ADDENDUM No. 03

Date: February 28, 2019

Coaldale Government Building

Project No.: 9030

1 TYPICAL CANOPY SECTION
 AASK2 Scale: N.T.S.

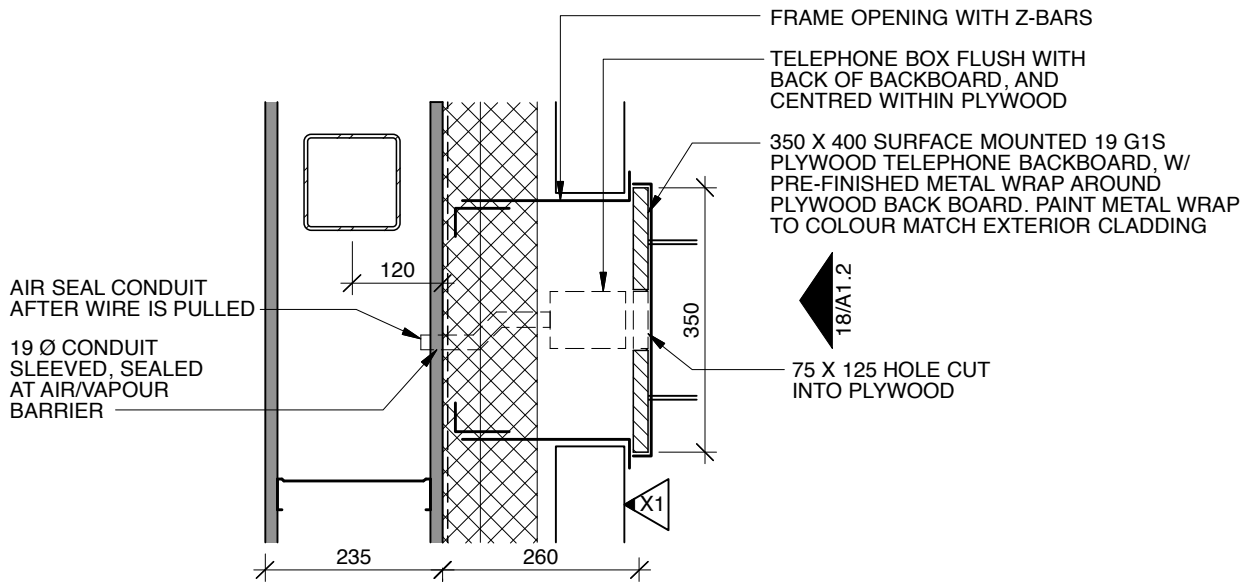
- .2 Refer to drawing AASK9 for widths of canopies and overhangs.
 - .5 A4.3 – Wall Section**
 - .1 Wall Sections 1/A2.2, 2/A2.2 and 7/A2.2 the underside of the fascia trim is 102 950.
Change reference marker Sim 7/A4.5 to read AASK 2.

- .4 Add: Detail AASK2.

1 WALL SECTION
 AASK8 Scale: 1:20

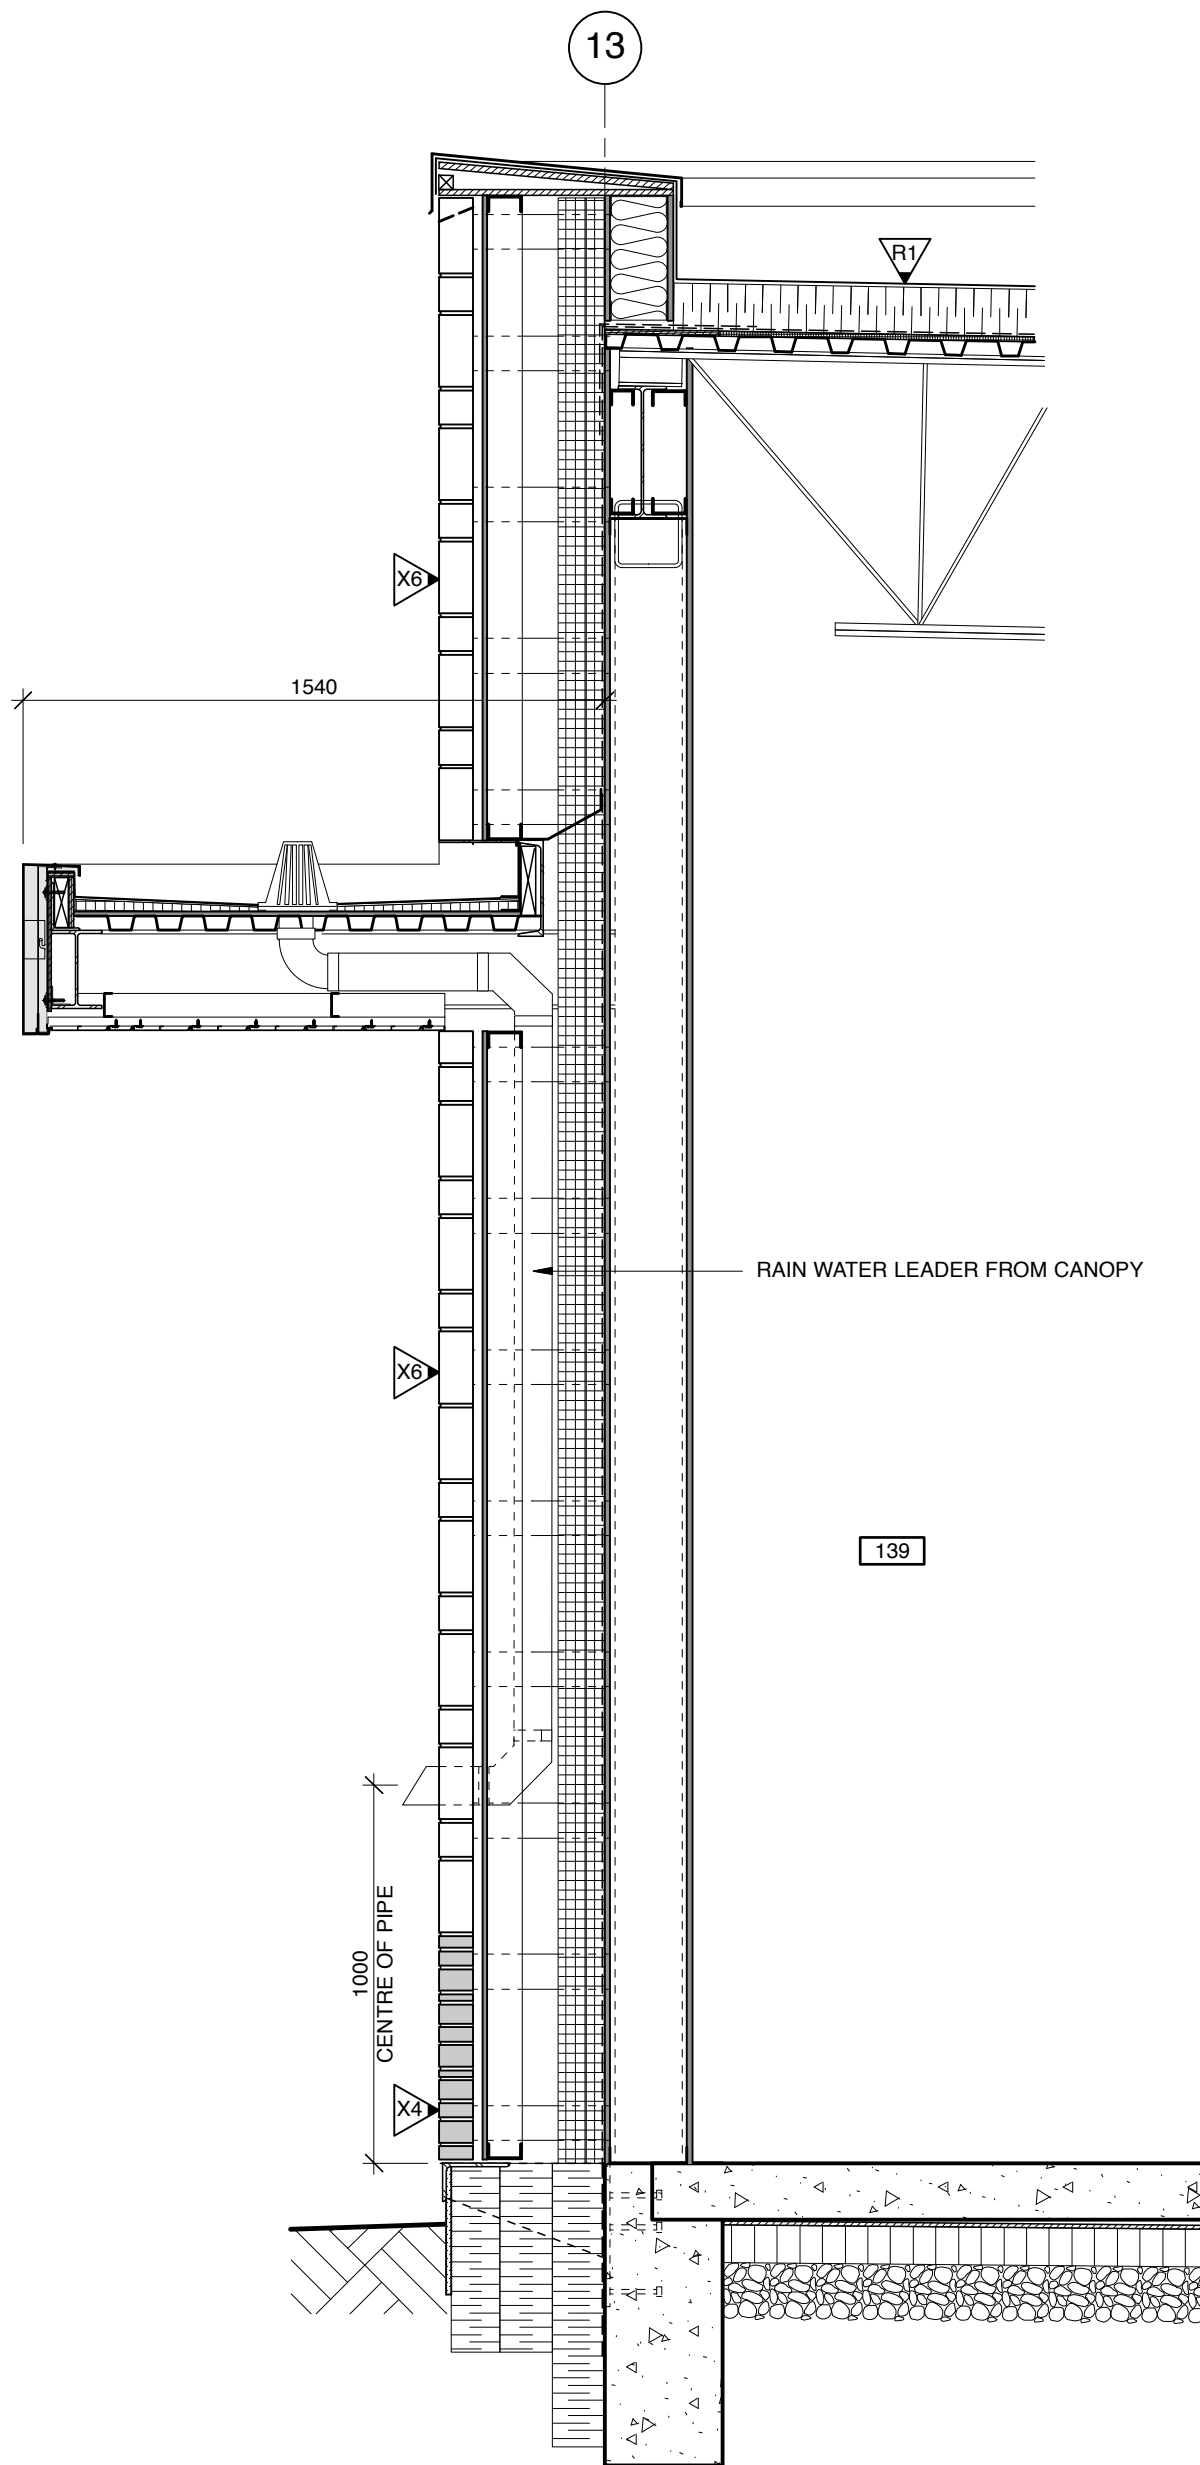
- .1 Add Detail AASK-10.
 - .2 Add Wall Section 1/AASK8.
 - .7 A4.5 – Wall Sections**
 - .1 2/A2.2 Revise dimension “2975” to read “2950”.
 - .3 Wall Section 4/A2.2 change note “3565 underside canopy” to read “3565 underside fascia”.

Drawing Title: **REFLECTED CEILING PLAN: CANOPY HEIGHTS**

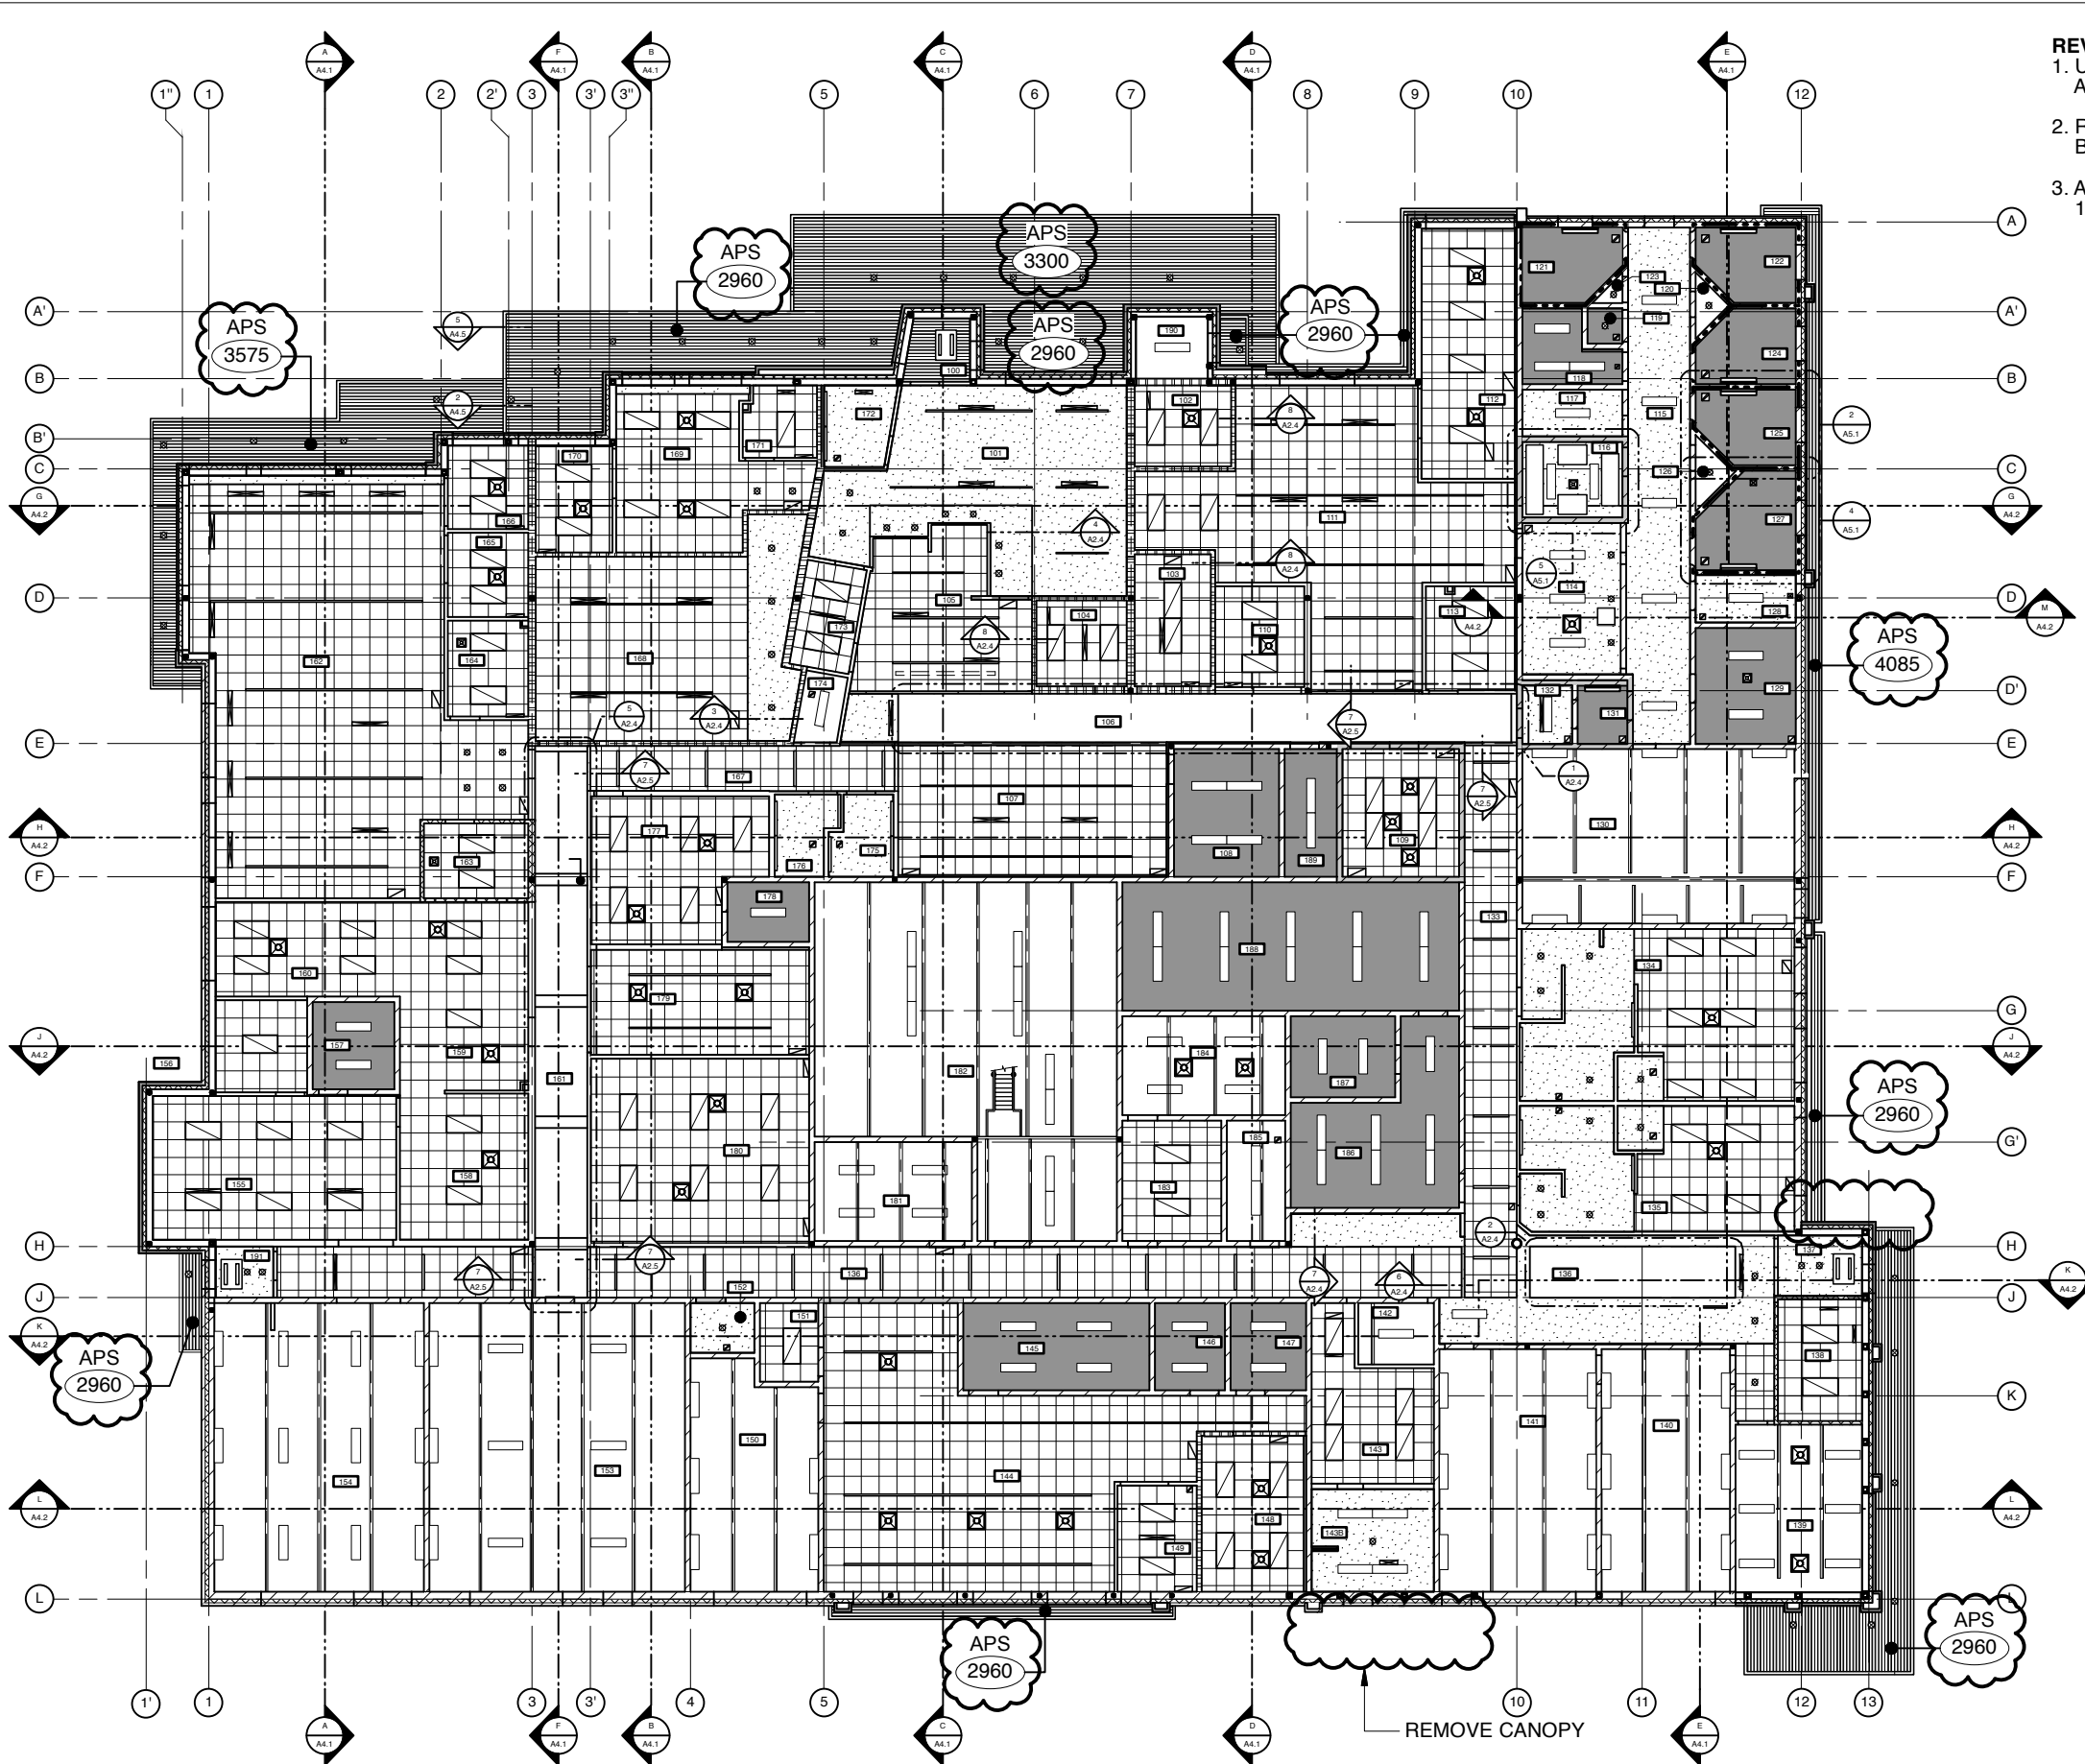
- .1 9/A2.4 – Main Floor Reflected Ceiling Plan.
Replace 9/A2.4 with AASK9.
 - .3 A2.8 – Out Building Floor Plan, Elevations, Sections and Details**
 - .1 Roof Types
R5 Revise to read:
“Standing seam metal roof:
-75mm Z-Bars at 600 on centre (provide 6mm Ø drain holes at 600 on centre at bottom of vertical face).
-50mm semi-rigid insulation
-Grace ice and water shield membrane
-gypsum sheathing board
-metal deck

- REVISIONS:**
1. UNDERSIDE OF SOFFITS TO BE ADJUSTED AS SHOWN.
 2. REMOVE CANOPY ON SOUTH SIDE OF BUILDING ALONG GRIDLINE 'L'.
 3. ADJUST CANOPY AT GRIDLINE 12/H AND 13/H. REFER TO AASK1.2 FOR DIMENSIONS.

Drawing Title
CANOPY ROOF PLAN

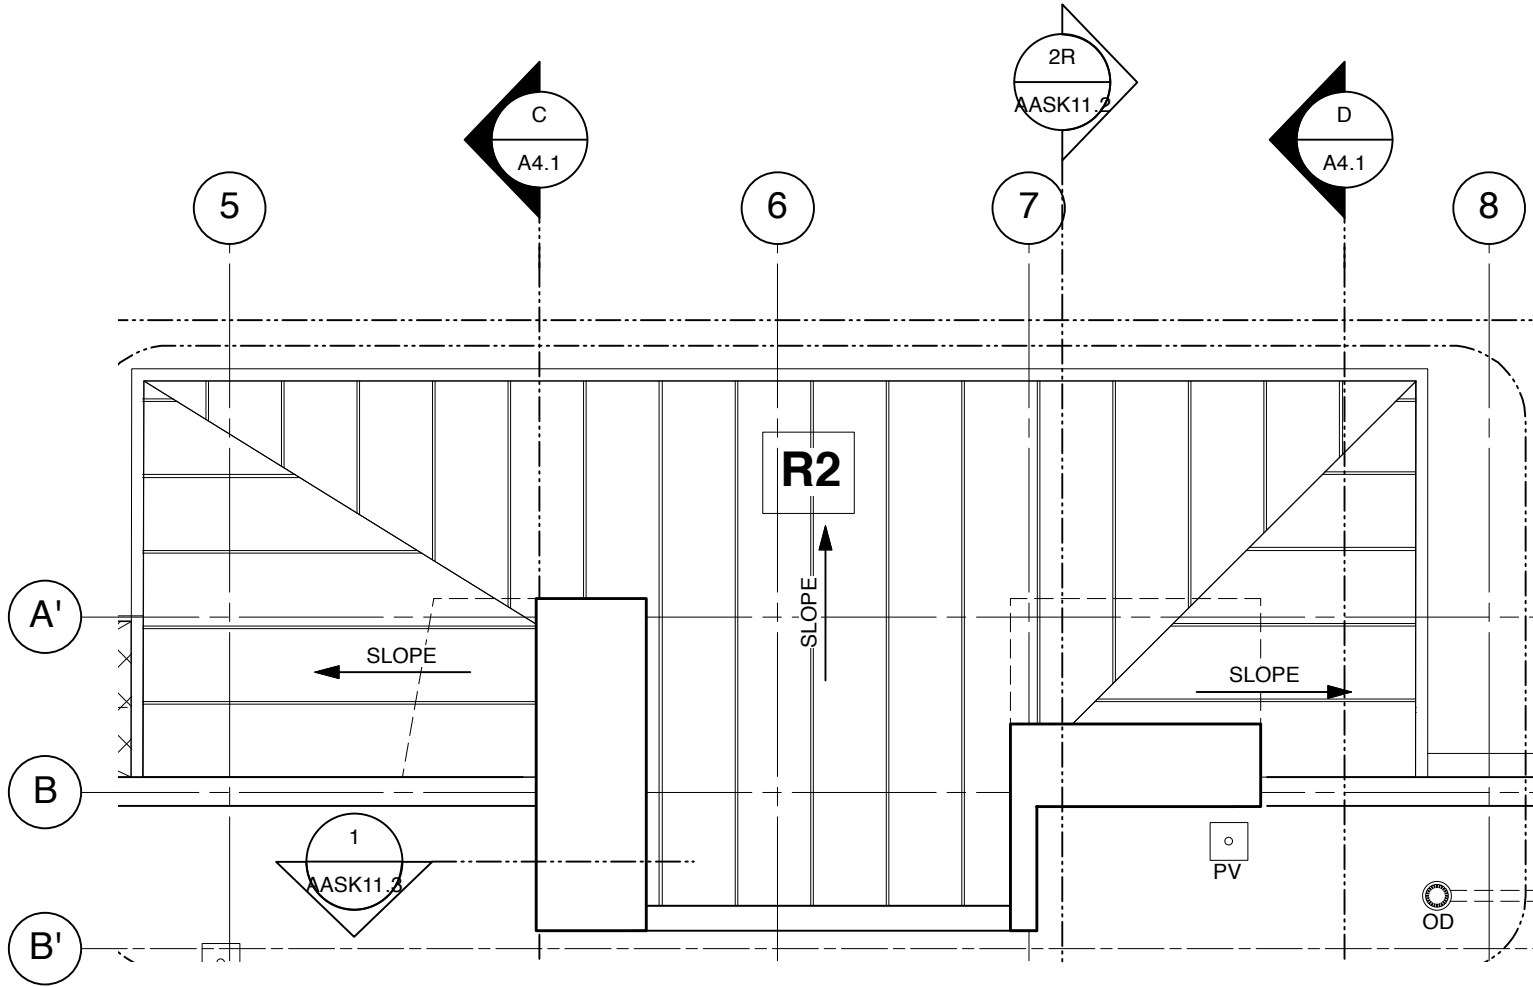
- .10 A4.8 – Roof Plan Large Scale North Hip Details**
 - .1 1/A4.8 North Roof Plan.
 - .1 Refer to revised Roof Plan AASK11.1
 - .2 Add AASK 11.2 and 11.3 referring to additional sections through the canopy roof.
